PD Modification Application:

PD-MM 24-0300

Development Services Department

AGENCY REVIEW COMMENT SHEET

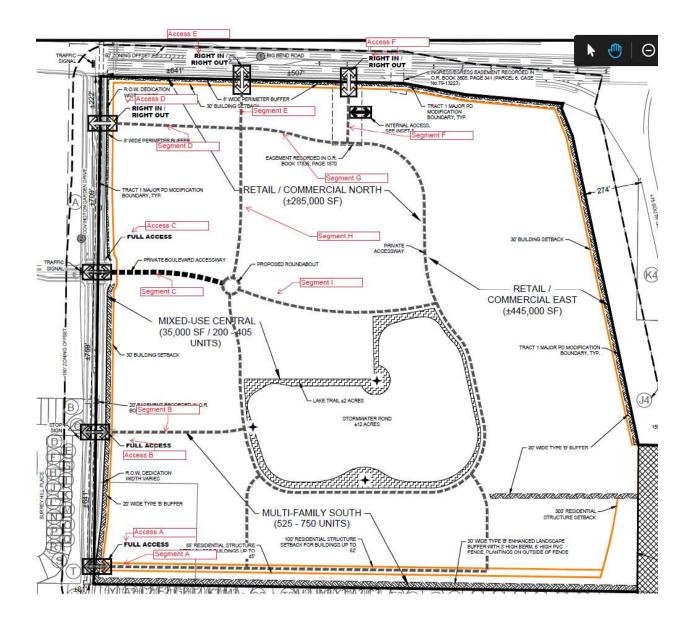
- Prior to PD certification, the developer shall revise the site plan as follows:
 - Remove the note located immediately underneath the legend on sheet 2 of 3. Additionally, the developer shall remove related site note 8 on the same sheet which states "Location of access drives are conceptual and subject to access management requirements."
 - o Delete note 9. Staff has proposed a PD condition addressing this issue.
 - Revise the site plan to label each project access and adjacent roadway segment as in the markup provided below.

Exhibit A: Proposed Outparcel Entry from Big Bend Road

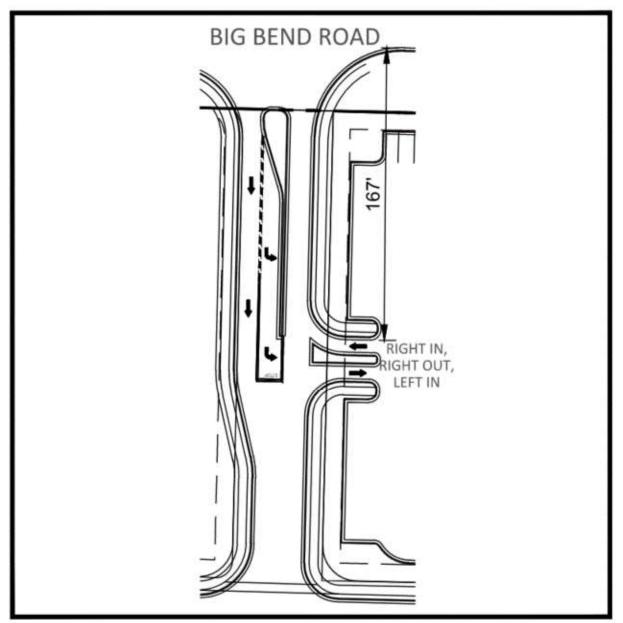
Based on the information provided by the applie	cant, this request is:
Disapproved	
Approved	
Approved with Conditions	
If there are any further questions or you need cl Sheida L. Tirado, P.E. (813) 276-8634, TiradoS@	* •
	Sincerely,
	Michael J. Williams Hillsborough County Engineer

Exhibit A: Drawing TND-3

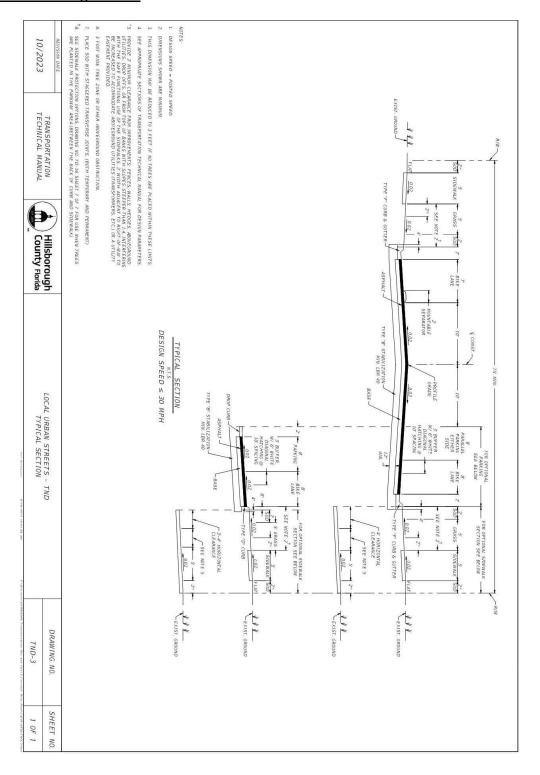
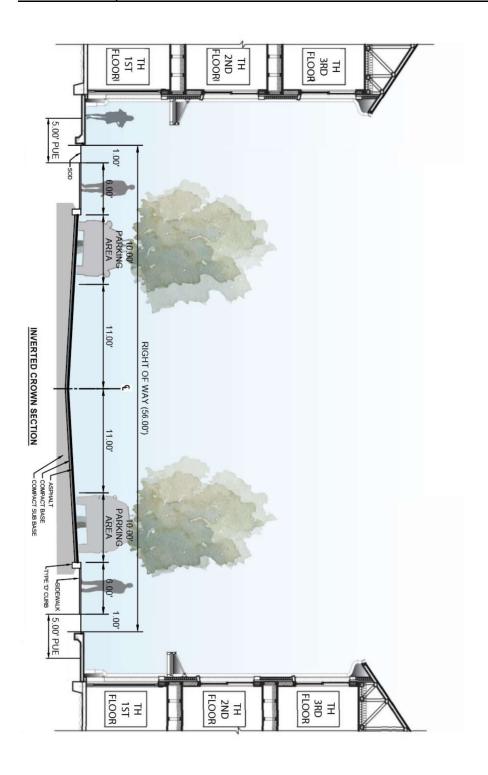
Given the scale (only a maximum of 100 townhomes) and location, the Design Exception is specific to Drawing TND-3, shown as Exhibit A. The request is to decrease the typical section from 75 to 56 feet. The primary purpose of the Design Exception is to create an efficient layout that conforms to the unique setting within the mixed-use project and provides more of an urban neighborhood feel. Transportation is comprehensively addressed through the PD Site Plan, providing the location of 10-foot bike and pedestrian sidewalks throughout the community, see Exhibit C.
